Accessibility Audit

Low Hall Nursery School

Low Hall Lane

Date 07/03/2017

Photo 19

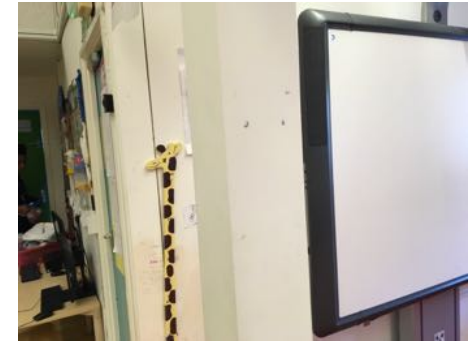
Question	Response	Details
<p>7.1 - Corridor wide enough for a wheel chair user to manoeuvre and for other people to pass? Turning space for wheel chair users?</p>	<p>B</p>	<p>On approach to the reception from the main entrance, the central units are narrowing the available clearance widths for wheelchair users. The central units are also the same colour as the flooring causing a potential collision hazard.</p>
<div data-bbox="118 394 441 638" data-label="Image"> </div> <p data-bbox="237 687 322 708">Photo 19</p>		
<p>7.2 - Free from obstruction to wheel chair users and from hazards to people with impaired sight? Are there any internal columns that have a lack of colour contrast?</p>	<p>C</p>	<p>Within the main central hub there are two columns which are white seen against a white background (from some angles) These should be colour contrasted to ensure that they do not pose a potential collision hazard.</p> <p>The wooden play structure within the central hub should have the edge of the steps painted to highlight them.</p>
